Providence City Plan Commission

AGENDA ITEM 3 ■ 311 KNIGHT STREET

OVERVIEW

1ST FLOOR PLAN
311 KNIGHT STREET

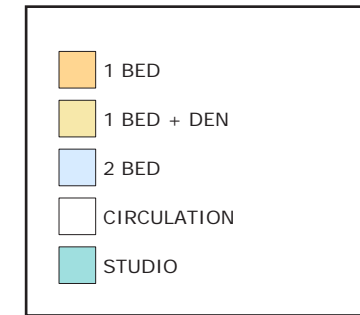
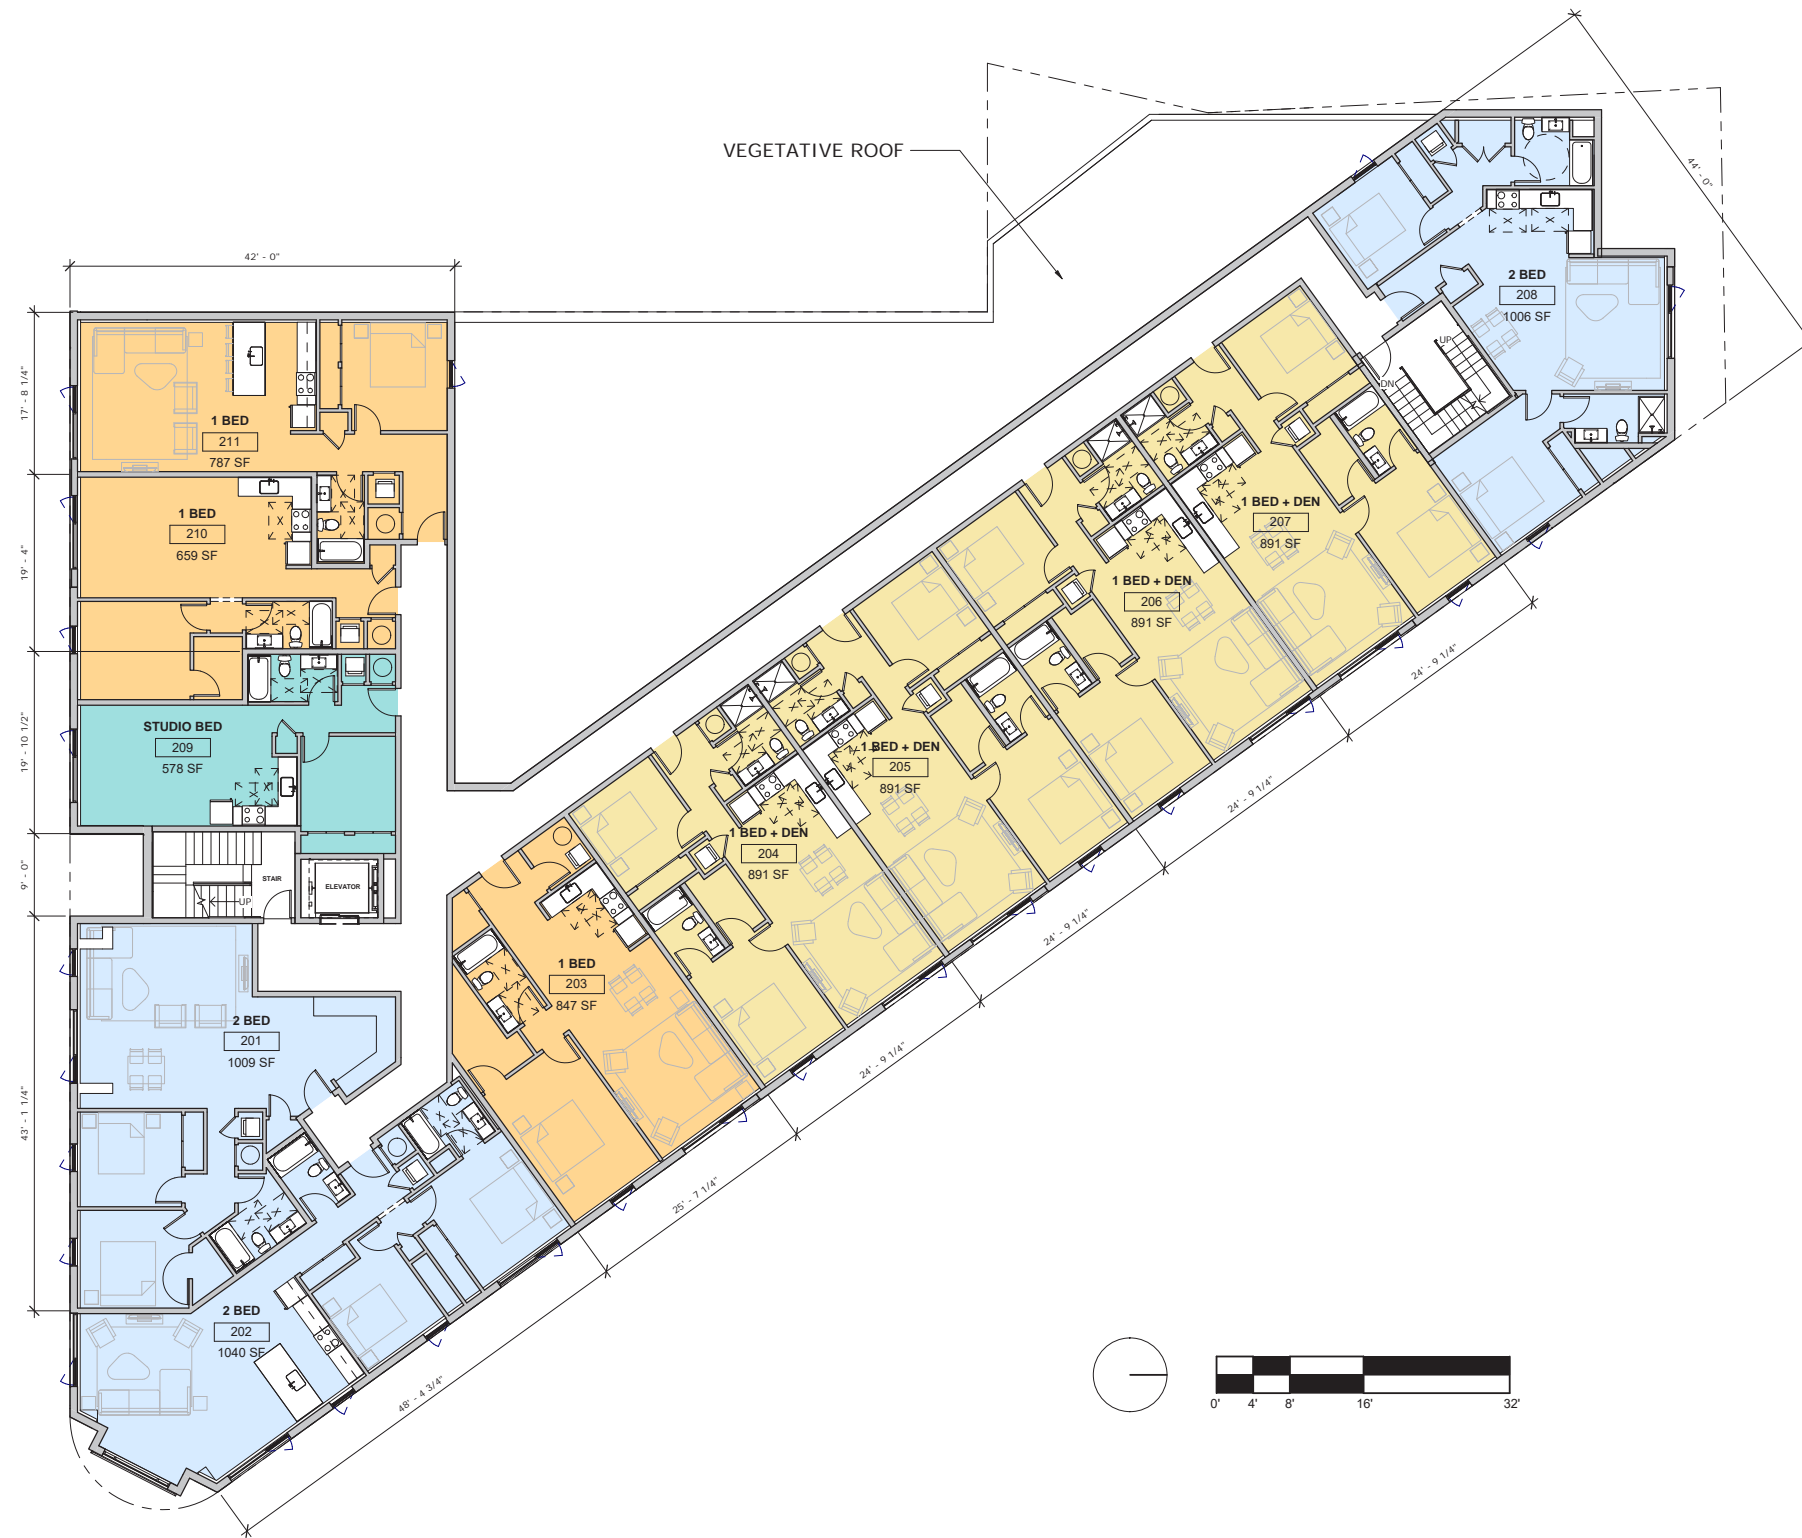
With additional units proposed, 41 parking spaces are required for the development, calculated as one per dwelling unit. No parking is required for the 1956 SF of commercial space as the first 2,500 SF of commercial space is exempt from providing parking in the C-2 zone. Thirty six internal parking spaces will be provided on the first floor. Therefore, the applicant is requesting an adjustment for five parking spaces.

The applicant is requesting a dimensional adjustment for five parking spaces where 41 spaces are required but 36 internal spaces will be provided.

The site is irregularly shaped with internal parking provided from a vehicular entrance on Westminster Street. The lot is not large enough to accommodate parking for all 41 units, and comply with the requirement to provide commercial space on the first floor of a main street. Westminster Street is considered a main street, a busy commercial corridor that offers ample onstreet parking, public transit access and bicycle infrastructure, which can make up for the shortfall of five spaces. Long term bicycle parking will be provided in the parking area, which would further reduce the reliance on vehicle parking. The applicant has indicated that a shortfall in parking spaces could be made up by leasing spaces offsite. However, these spaces cannot be considered in the parking calculation as they cannot be deed restricted to parking for the building. It is the DPD's opinion that the CPC should grant the requested adjustment, finding that it is required due to the nature of the site, and recognizing that the applicant will provide mixed used development with at least 50 percent residential development and structured internal parking as amenities.

1. The CPC should grant the dimensional adjustment for five parking spaces, finding that it is required due to the site's layout and that the applicant has provided mixed use and indoor parking as amenities to be eligible for the adjustments.
2. The CPC should approve the major change to the plan.
3. The applicant shall merge the lots prior to final plan approval.
4. The applicant shall obtain encroachment permits for the building footings at the final plan stage.
5. Final plan approval should be delegated to DPD staff.

WESTMINSTER STREET ELEVATION
 311 KNIGHT STREET

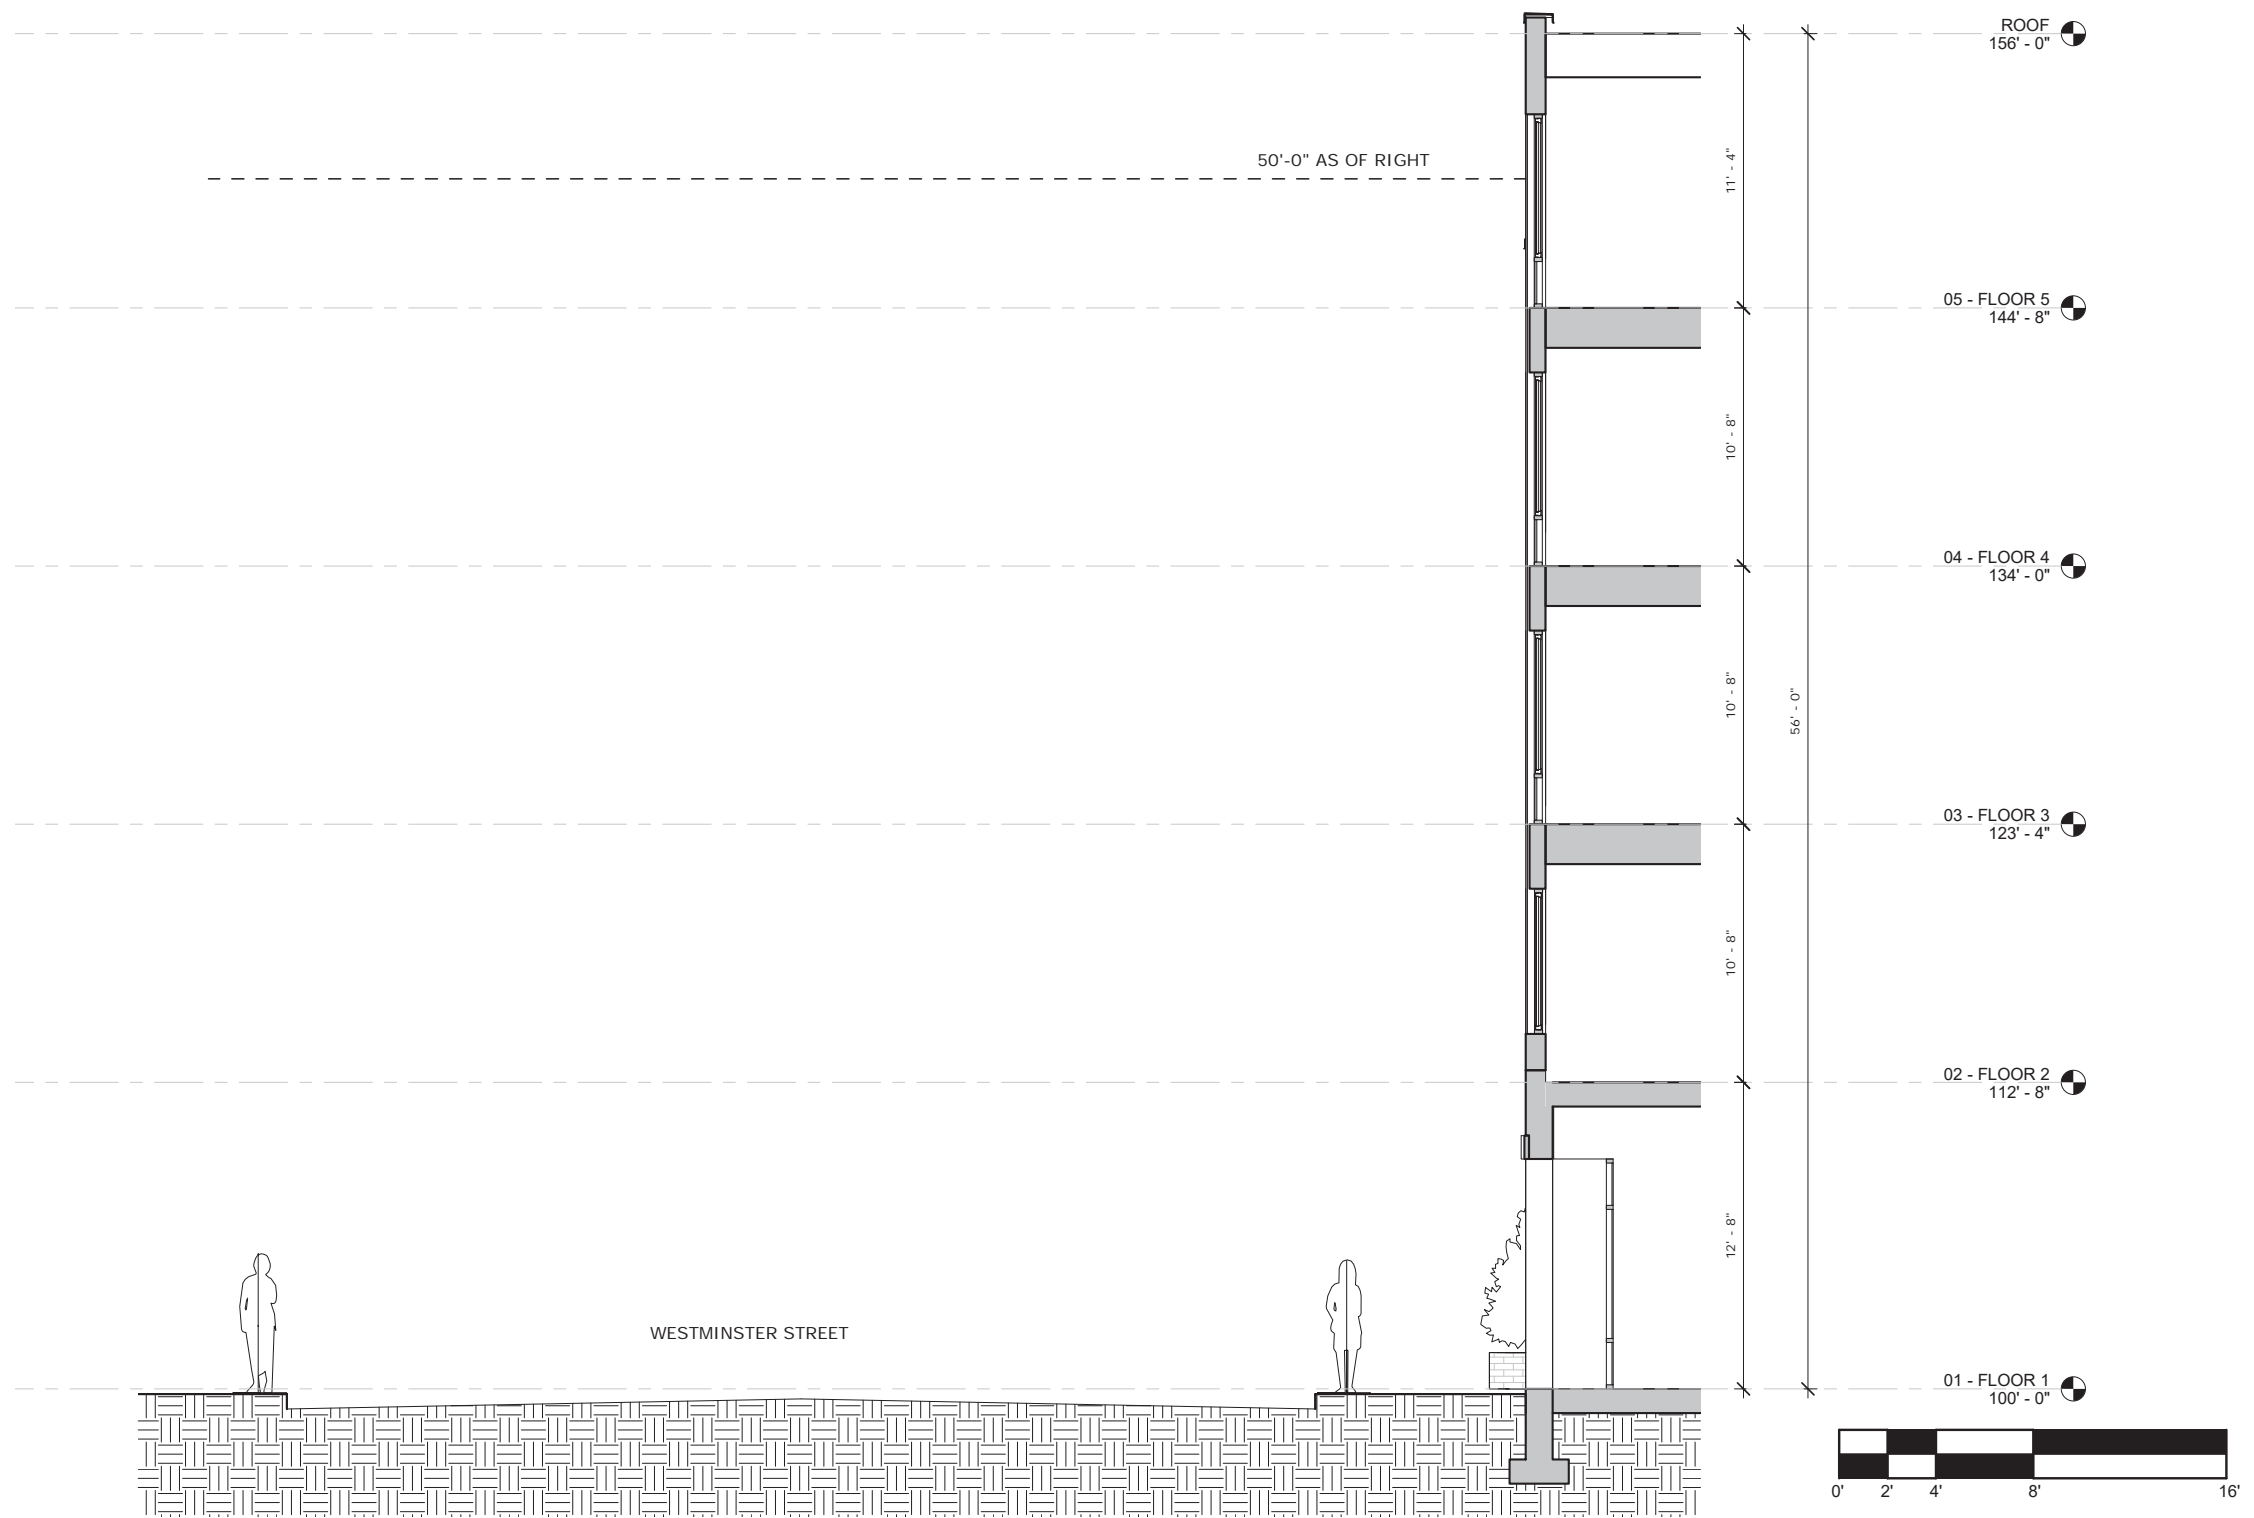
The applicant is requesting a design waiver from section 503.A.3 of the ordinance, which requires that ground floor façades shall contain a total area of 50 percent or more transparency of the wall area. The applicant is seeking a waiver from this requirement with 24% of transparency provided. Based on provided elevations, the building lobby and commercial areas on Westminster and Knight Street will be completely transparent. The opaque areas on the façade correspond to the parking area and will be detailed with green walls with plantings. As discussed, the building's layout is related to the unique configuration of the property. Parking in proximity to Westminster Street is required for the development to provide access from a main street and to serve vehicles traveling to the development. It is the DPD's opinion that shielding the garage from public view would better serve the streetscape as it would prevent the façade from being dominated by views of the parking area. The landscaping would provide some variety to the façade, so as to not render it completely blank. The DPD recommends that the CPC grant the waiver, finding that it is related to the unique character of the property.
